ATTACHMENT B
TO THE 11/12 SEPTEMBER 2008 STAFF REPORT
CEASE AND DESIST ORDER FOR THE CITY OF DIXON

GROUNDWATER DISCUSSION

Figure 1
Distribution of TDS in Groundwater

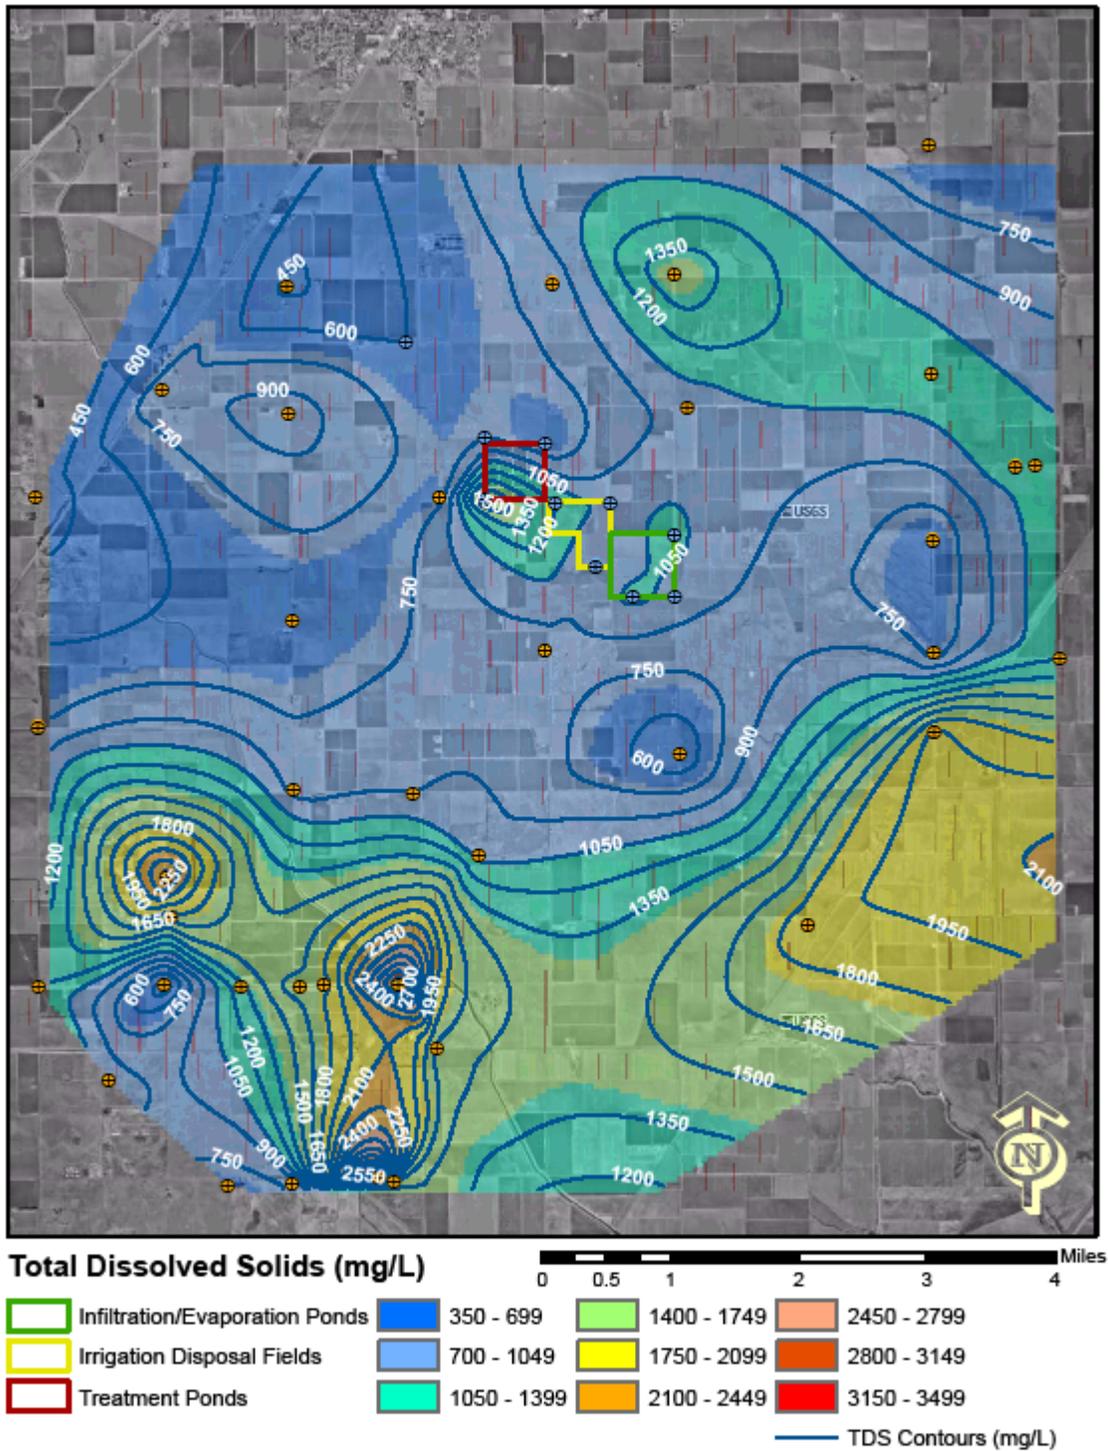
However, staff notes that the elevated salinity levels in groundwater near WWTF are surrounded by better quality groundwater, as shown in Figure 1 and 2 (attached). Therefore, migration of the WWTP effluent in the subsurface has the potential to degrade intervening groundwater between the WWTP and the higher salinity areas farther downgradient.
